Dixie-Narco®

Service Bulletin # _____ Date: September 10, 1981

MODEL: DNCB 630/360-5 and -6

SUBJECT: Vend Motor Assembly with original Linkage Arm - C236,070,200.13.

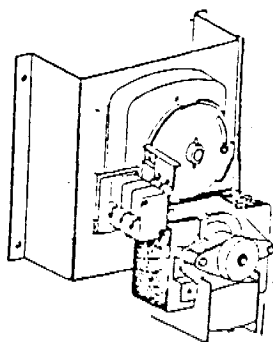
REASON: Since the diameter of the pin on the oscillator has been increased, then the ID of one of the holes in the linkage arm has been increased also.

Vend Motor assemblies will continue to be shipped with the original linkage arm. So that the Vend Motor will adapt to any DNCB 630/360-5 & -6, the revised linkage arm will be included but not installed.

1	A801,201,030.01	Linkage Arm-Revised
1	801,804,770.01	Nyliner-Revised
1	801,803,160.01	Nyliner-(No Change Made)

CAUTION: Make sure the Linkage Arm is compatible with the pin of the oscillator.
